From:	Matthew Armstrong <matthew.armstrong@hertfordshire.gov.uk></matthew.armstrong@hertfordshire.gov.uk>
Sent: To:	27 October 2022 11:45 Phil Roden; Lee Kendall
Cc:	Shaun Greaves
Subject:	RE: 21/03380/FP at Land To The North And East Of Great Wymondley, Hertfordshire - HCC Ref NH/10262/2021
Attachments:	Response_21-03380-FP.pdf

**Subject:** RE: 21/03380/FP at Land To The North And East Of Great Wymondley, Hertfordshire - HCC Ref NH/10262/2021

Figure 1 Modelling output for receptor 11 at a height of 1.5m

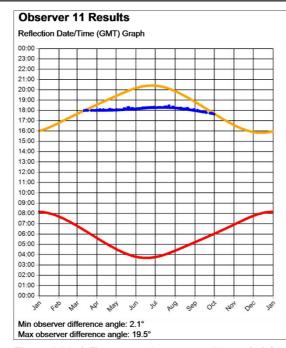
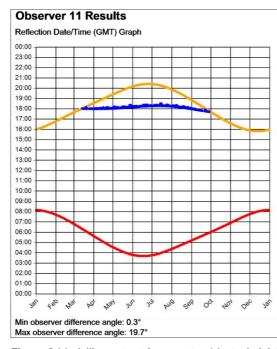
Hertfordshire County Council has identified that the typical eye height of a driver is 1.05m above ground level (agl). The initial Solar Photovoltaic Glint and Glare Study completed the modelling based on an average typical observer height of 1.5m. Road user heights can vary, so Pager Power assesses a typical road user height of 1.5m, to encompass an average, rather than a height of every possible road user. Changes by a few meters to the modelling height do not significantly change the modelling results, based upon previous project experience and expertise. The following discussion has been completed to assess the potential effects of a 0.45m change in height.

'[..] it is noted in the Glint and Glare Assessment that local roads have not been included in the assessment (p27), and that "a height of 1.5 metres above ground level has been modelled as this is a typical eye level for a road user" (section 4.3). All roads in the vicinity should be assessed, and a typical driver's eye height above ground level is 1.05 metres (refer to Manual for Street figure 7.17). More generally, it is not clear what the overall impact is on public highway users of glint and glare, and how the proposed mitigation measures will address this.'

The findings of the original glint and glare study remain unchanged following a review of the modelling in line with the response from Hertfordshire County Council.

Table 1 demonstrates the negligible differences in the times that the reflections occur, and the modelling outputs, found in Appendix A, show that there are no changes in the reflecting panel area for each receptor. Therefore, the conclusions made within the original study are applicable at this height and the results remain valid. Figures 1 and 2 below show the modelling outputs for receptor 11 at observer heights 1.5m and 1.05m, respectively.

Carriageway width measurements in 10 metre intervals

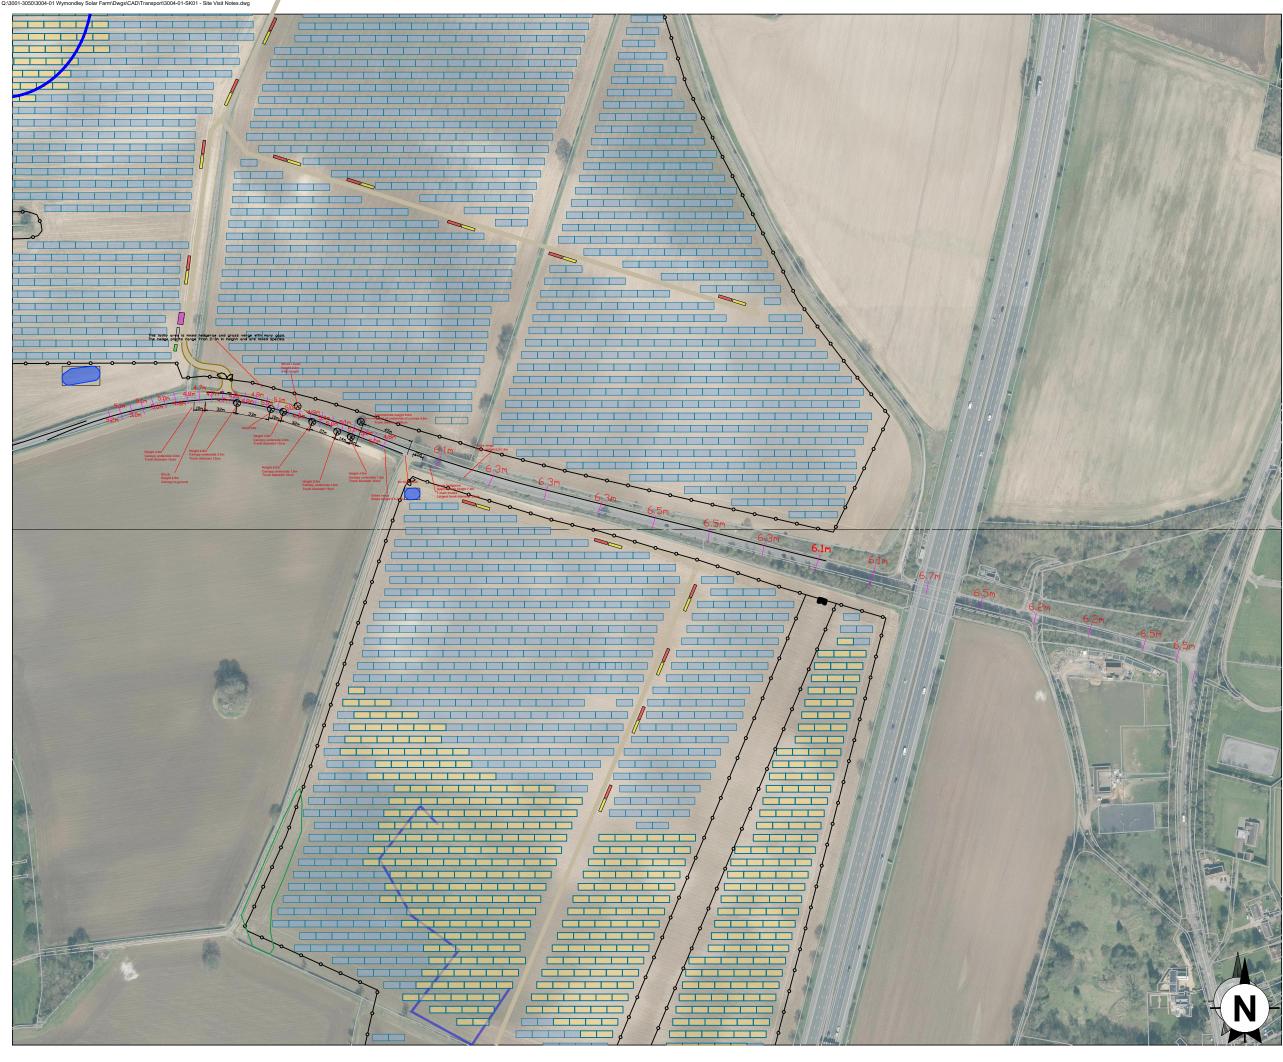
In terms of the wider approach route, it needs a proper audit undertaken by the applicant, with regular width measurements taken along it and some commentary as to how two large HGVs can pass by one another during construction. Do they need to provide the occasional passing place for example (to be secured by condition/s278, and reinstated after construction is complete)? The number of HGVs proposed during this construction is very significant, for a road which is rural by nature.

We have obtained carriageway width measurements at 10m intervals along the length of the visibility splays for the proposed northern site access junction, i.e. from a point approximately 105m west to a point approximately 140m east of this access. East of this point, measurements were then taken at 50m intervals as far as the junction with the B197. These measurements are included in the attached spreadsheet and illustrated on the attached pdf.

The measurements indicate that the width of Graveley Lane east of this point is consistently greater than 6m, varying between 6.7m at the widest point – underneath the A1(M) bridge – to 6.1m. This section of Graveley Lane is therefore of adequate width to permit two HGVs to pass in opposite directions.
